UNITED STATES PATENT AND TRADEMARK OFFICE

Office Action Summary	Application No. 10/804,881	Applicant(s) VESKOVIC, DRAGAN	
	Examiner Guiyoung Lee	Art Unit 2875

DETAILED ACTION

Fig. 9

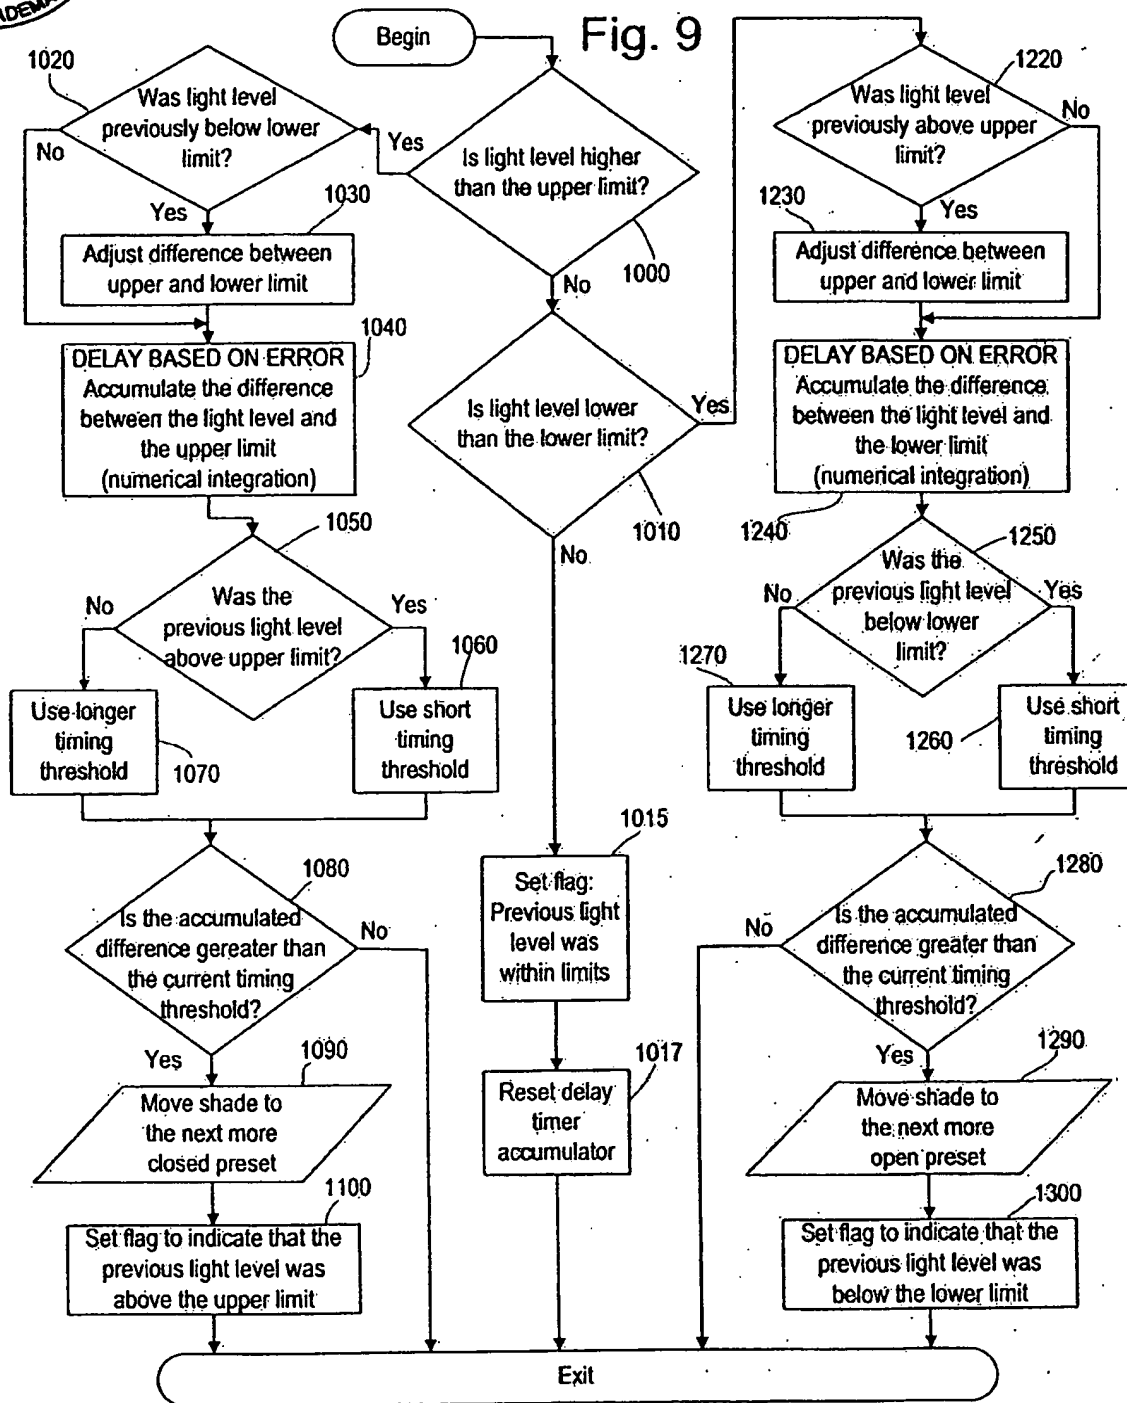
OK to
 Enter
 1-17-05
 LGY
